ORIGINATION FORM

Proposed Revisions to a Standard Plans Index
(Please provide all information – Incomplete forms will be returned)

Index Number: 649-031
Sheet Number (s): 2 & 5
Index Title: Signing for Motorist Services

Summary of the changes:

FOUNDATION AND BASE PLATE DETAILS

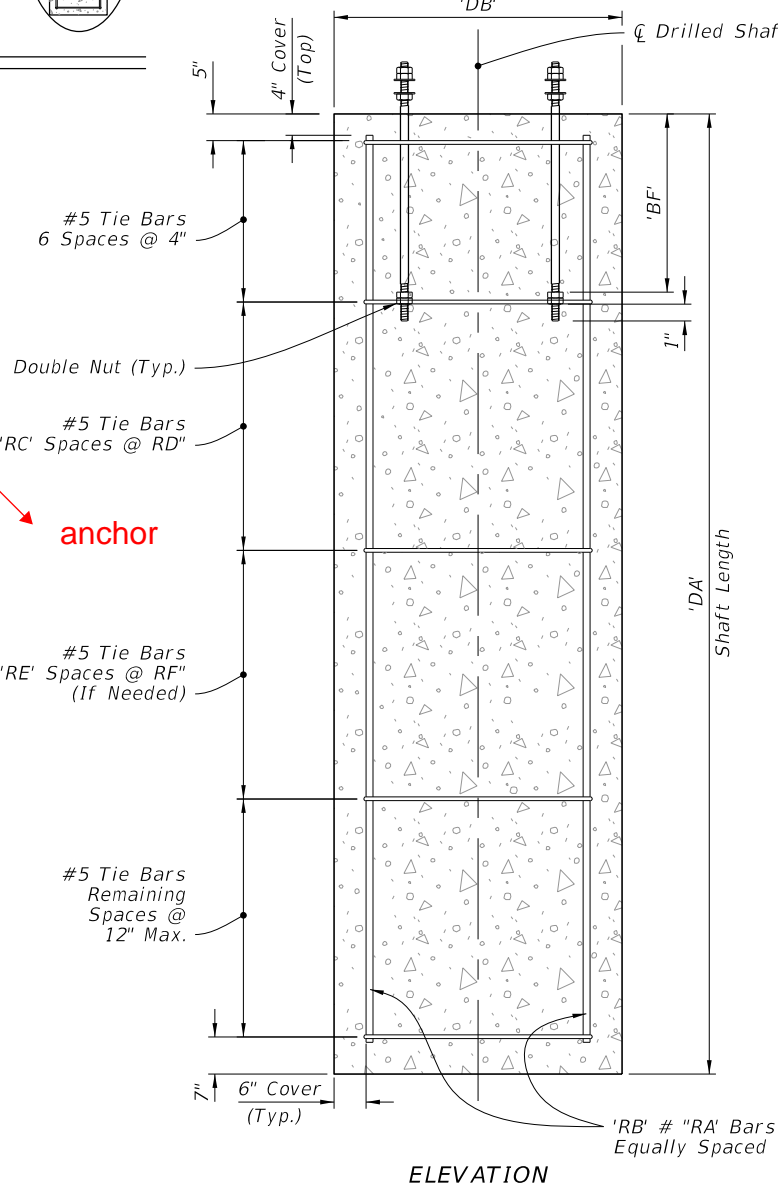
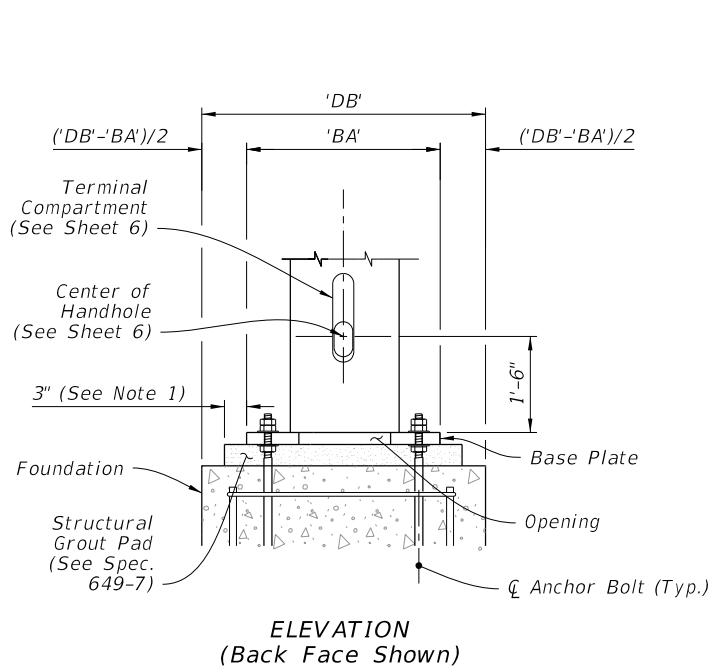
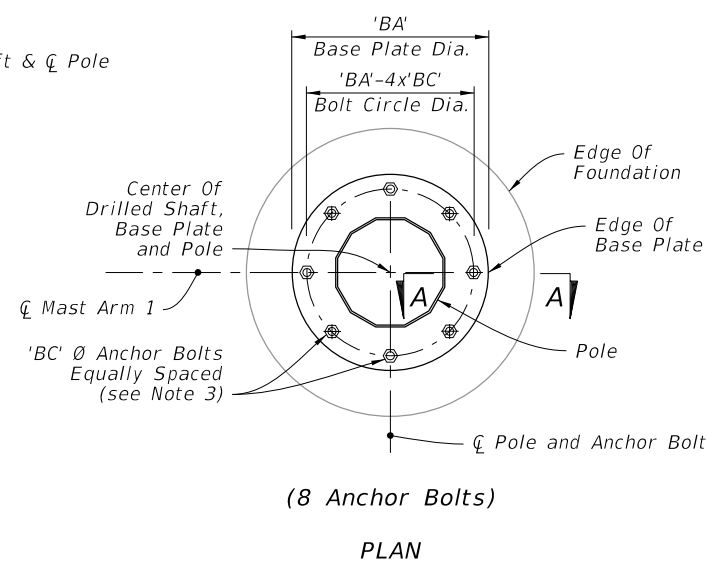
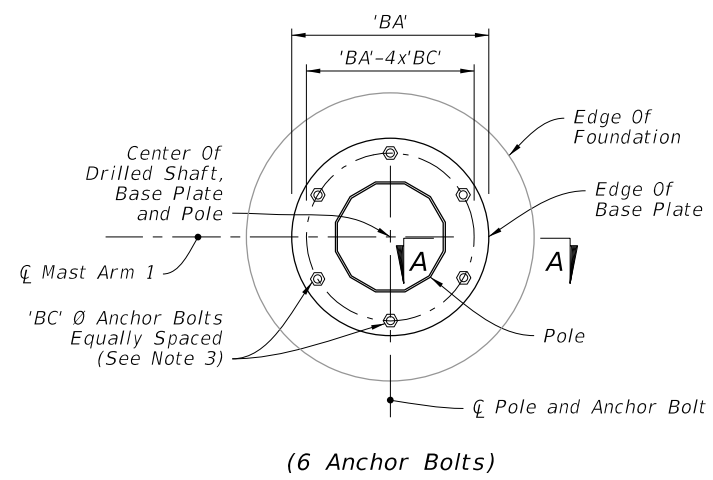
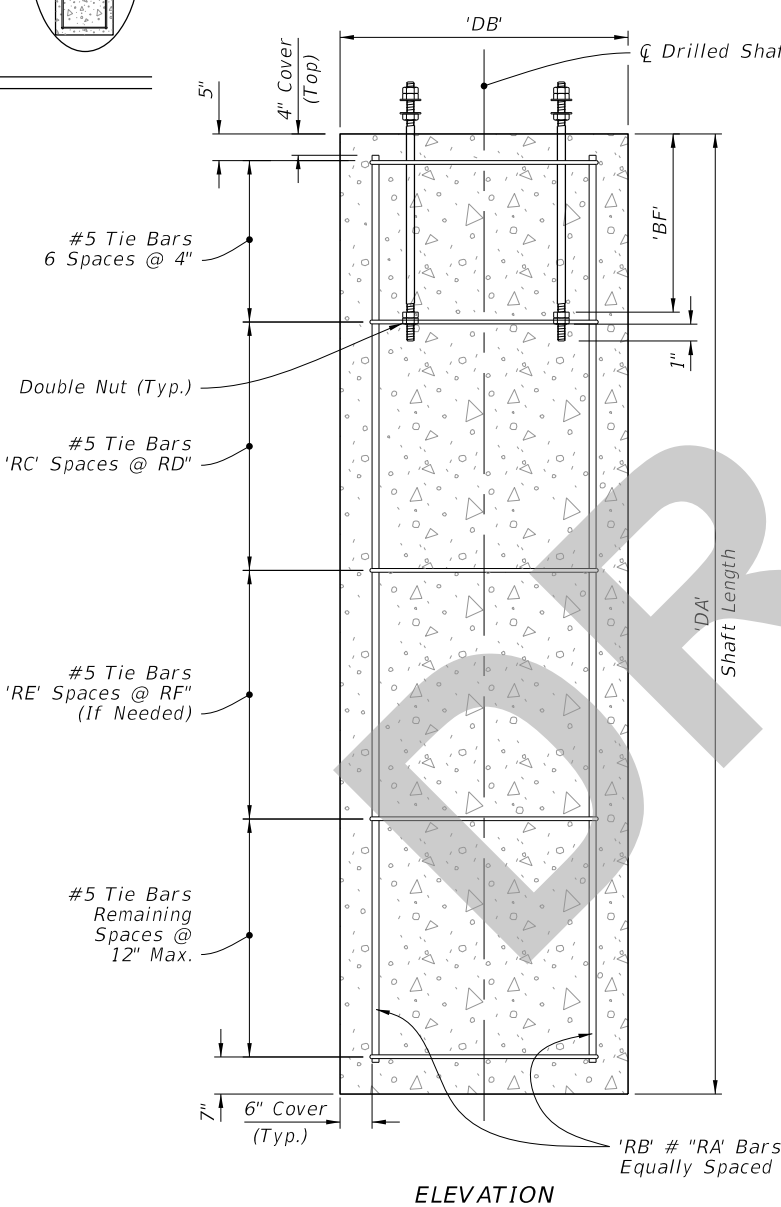
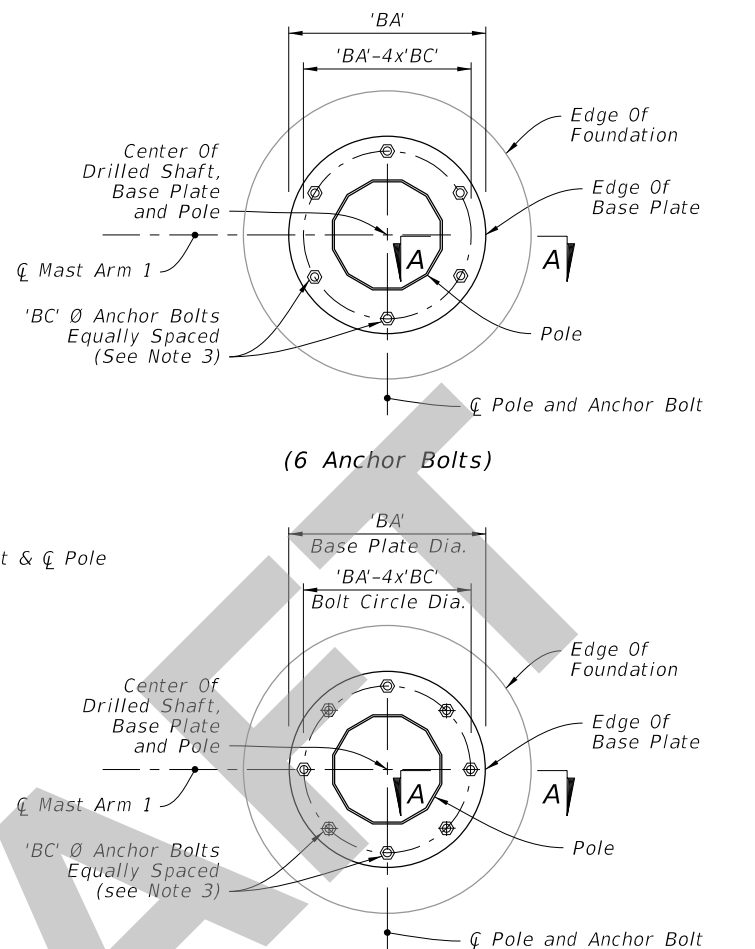
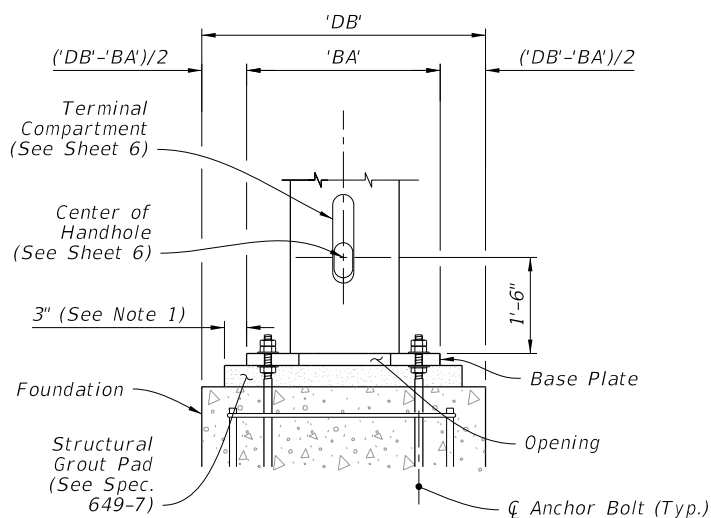
Sheet 2, Change Note 3: Half-height anchor 'jam' nut.
Sheet 5: Clarify that luminaire arms are to be galvanized steel not aluminum.

To follow spec 649 (in Industry review): For clarity the bottom nut is called an anchor nut. Common term for half-height nut is 'jam' nut which can be the top or bottom depending on the use. Only allow for bottom anchor nut for this application.

1. The Structural Grout Pad diameter may be reduced where the footprint of the Grout Pad does not provide adequate clearance for the sidewalk and/or accessibility considerations.
2. See Index 649-030 and the plans for actual quantity of bolts in the Base Plate Connection.
3. The bottom hex nut of the Double Nuts shown in Section A-A may be substituted by a half-height anchor 'jam' nut. Provide individual nut covers (not shown) for each bolt.

DETAIL 'G'
LUMINAIRE ARM AND CONNECTION DETAILS

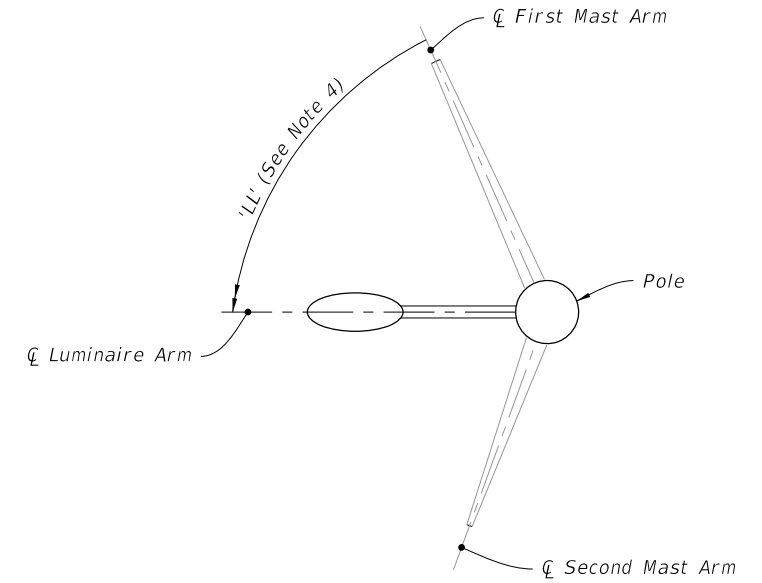
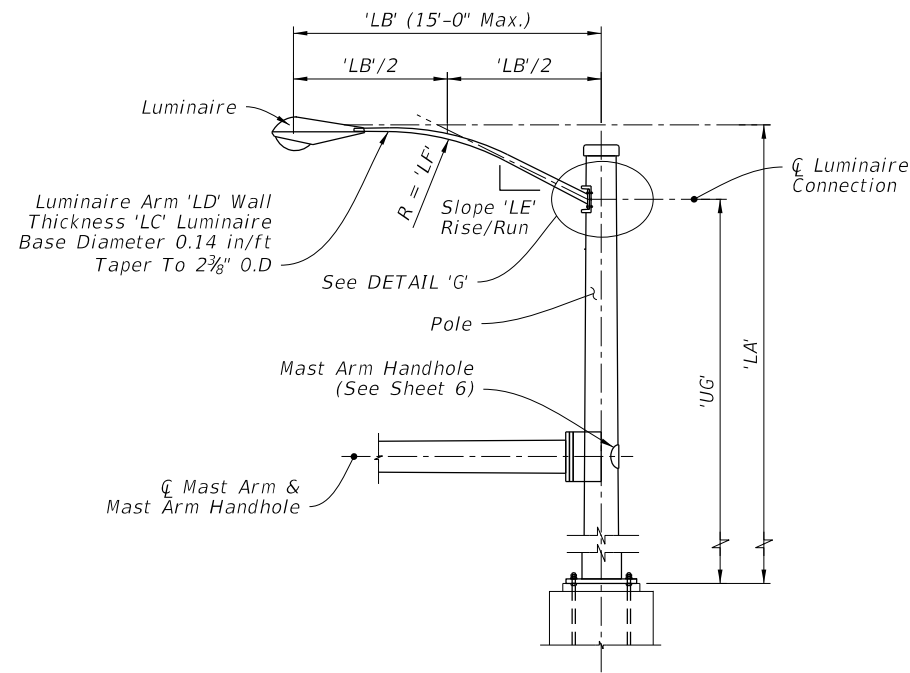
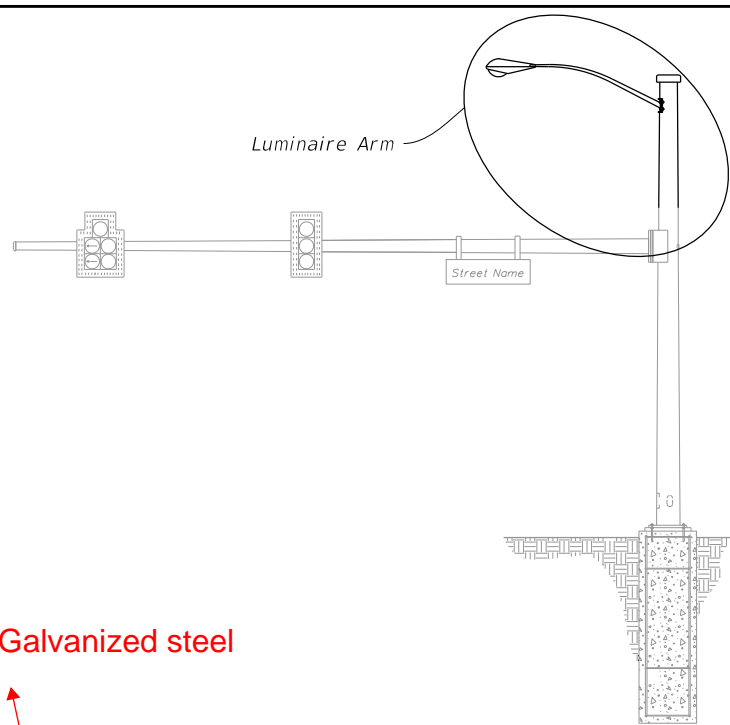
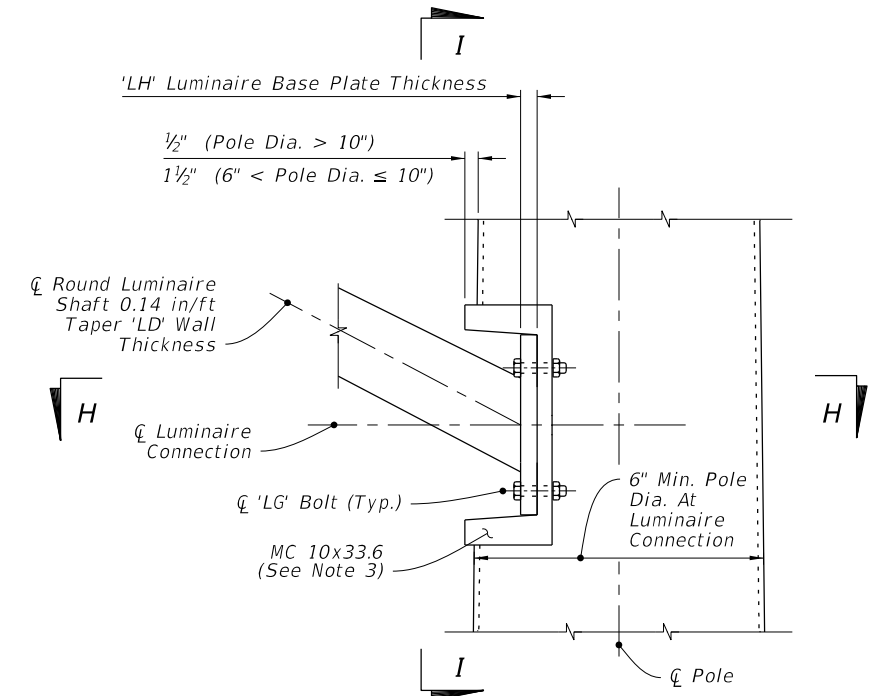
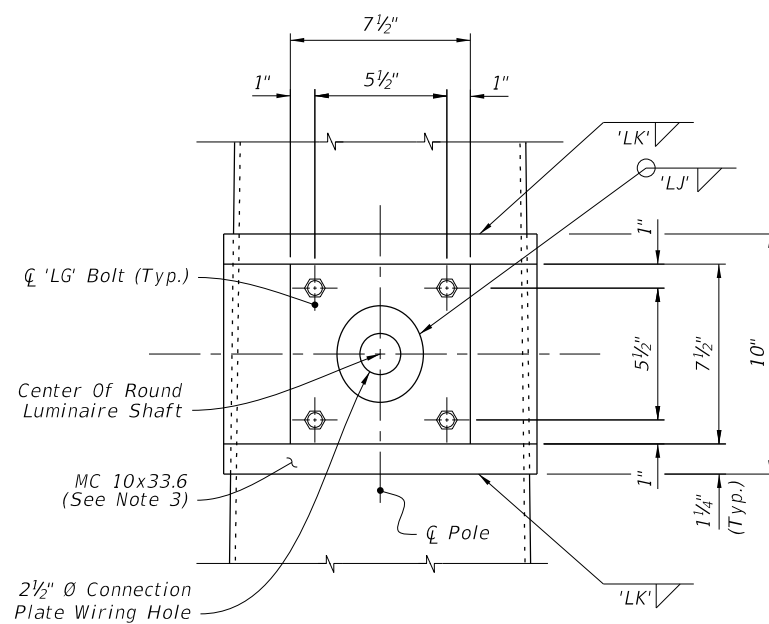
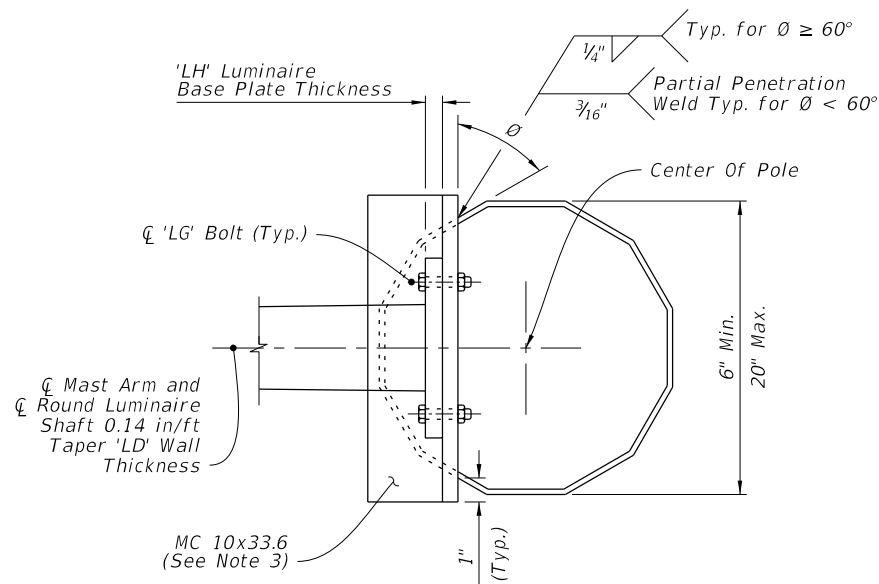
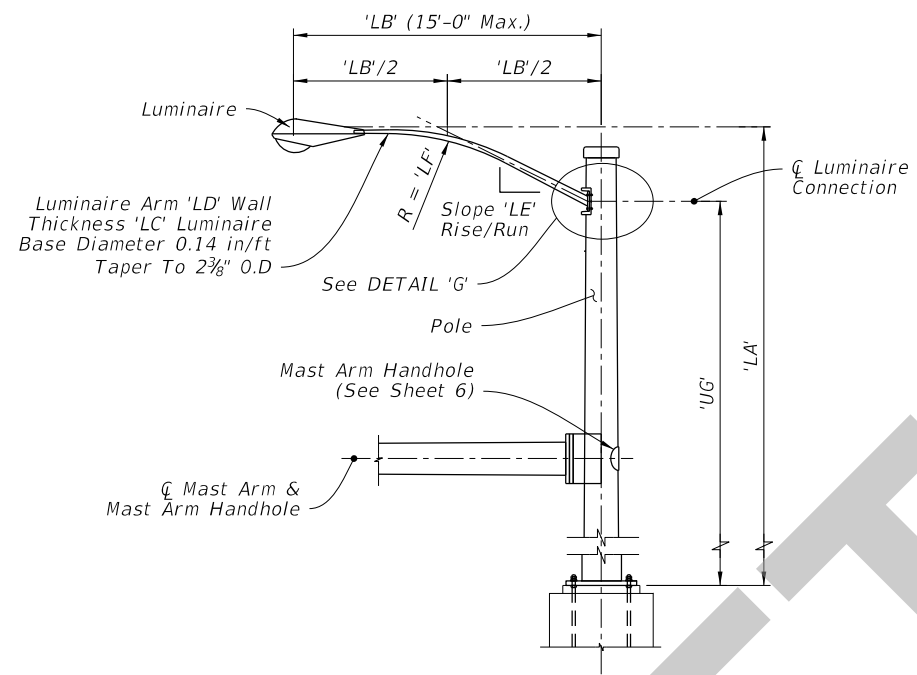
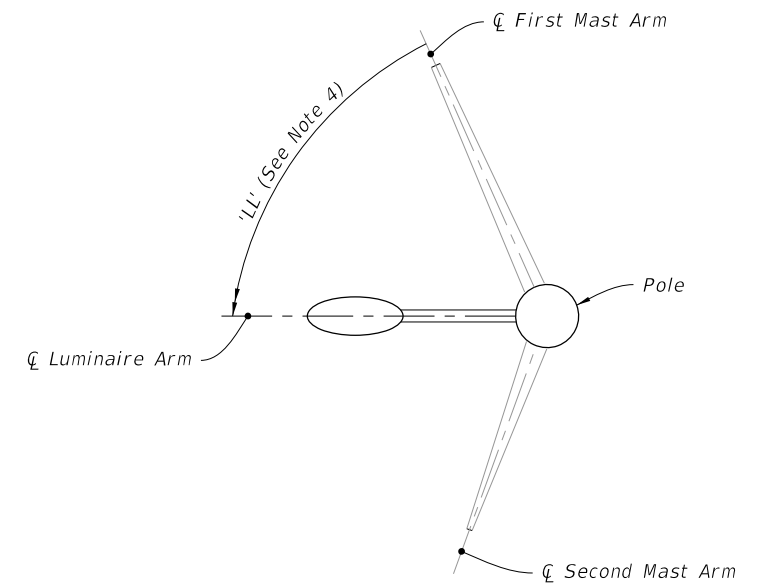
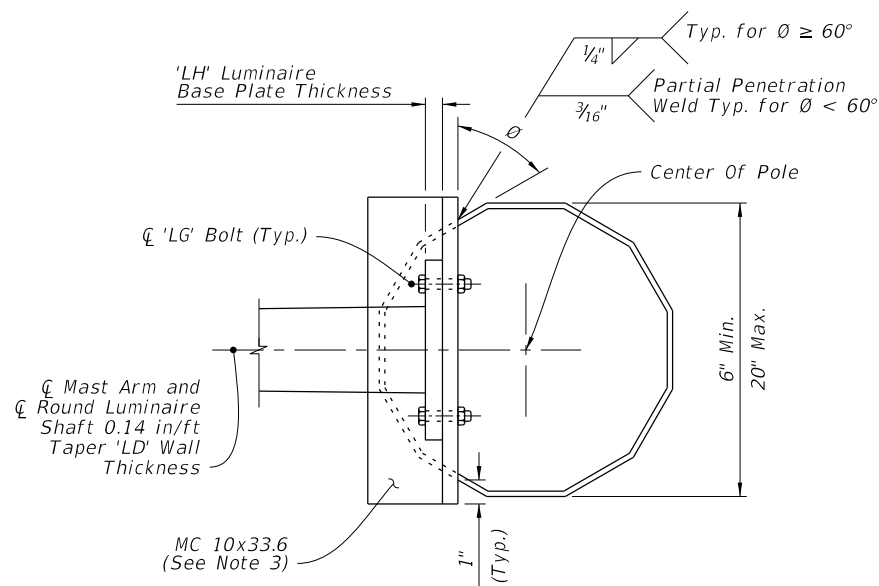
Galvanized steel

- Galvanized steel luminaire type and luminaire length may be found in the Lighting Plans.
- Align Luminaire Arm with Single Mast Arm or First Arm of Double Mast Arm unless indicated otherwise in the plans.
- The fabricator may substitute a 1/2" thick bent plate with the same flange width, height, and length as the MC 10x33.6 Channel section.
- 'LL' measure counter clockwise from First Mast Arm.
